# ADDENDUM 2

## Falmouth Head Start Center

### Comm. No. 2023108.01

### <u> ITEM 1 – S101:</u>

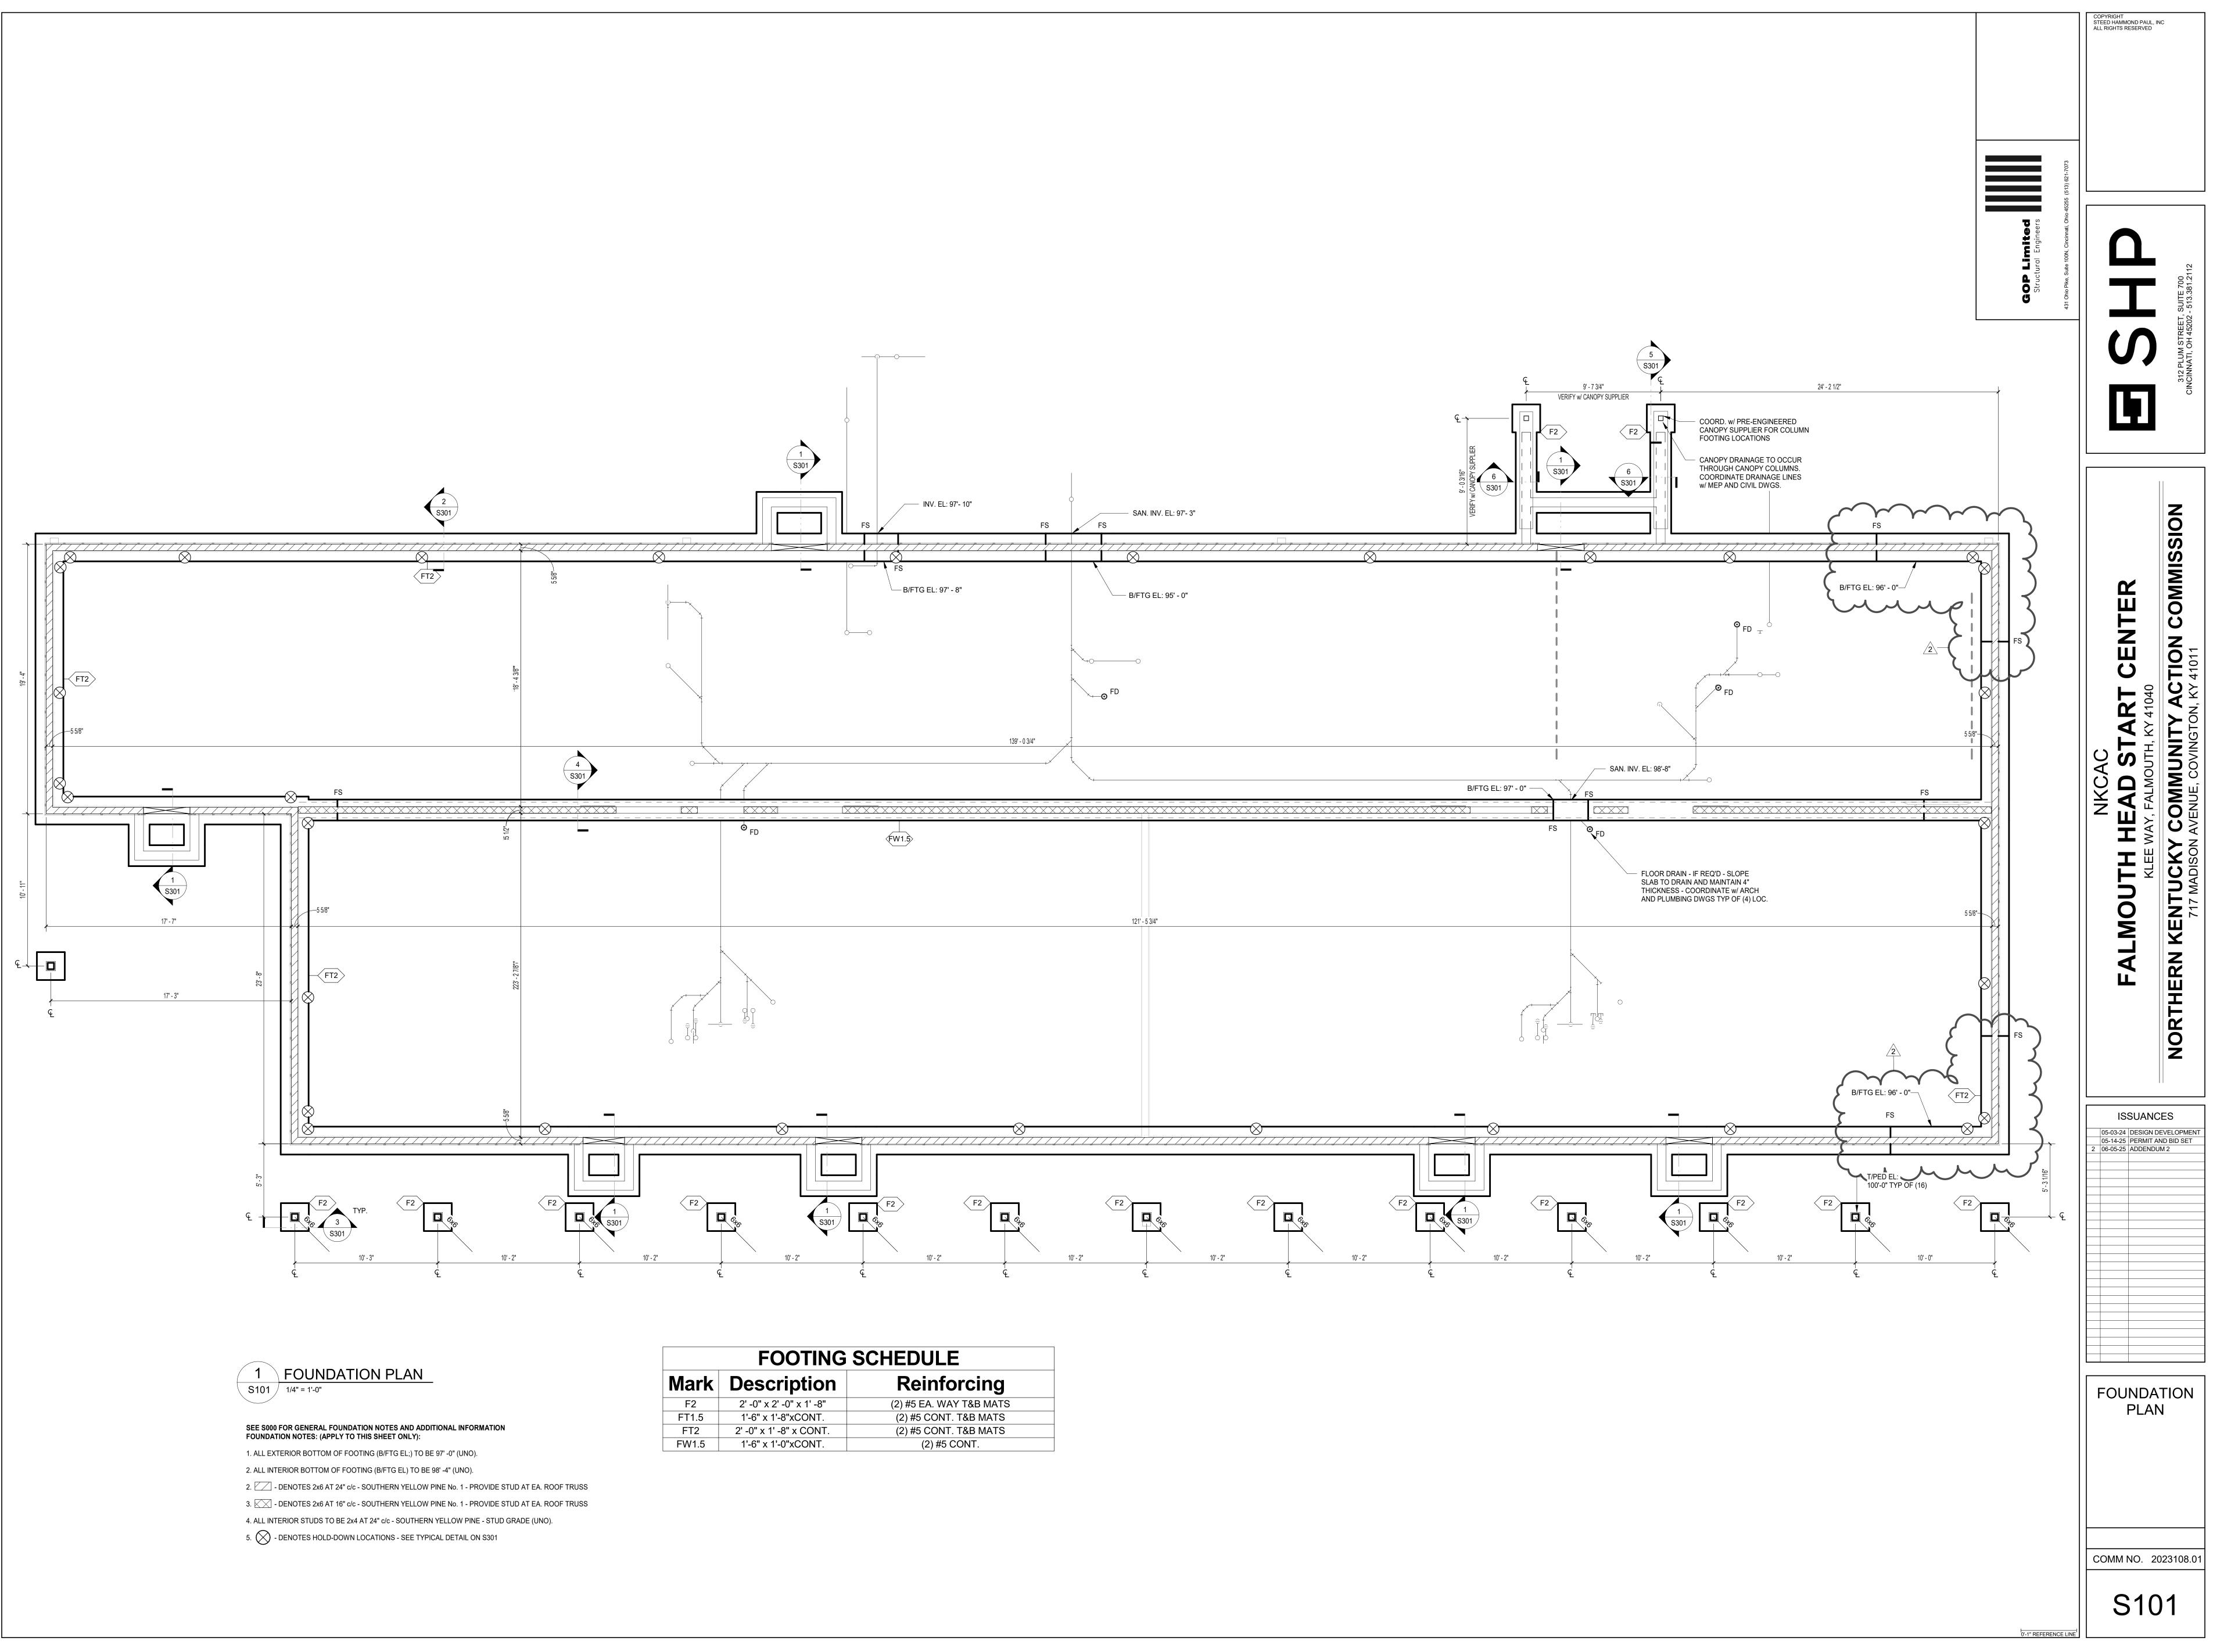
Footing elevations have been modified to accommodate civil grading plan.
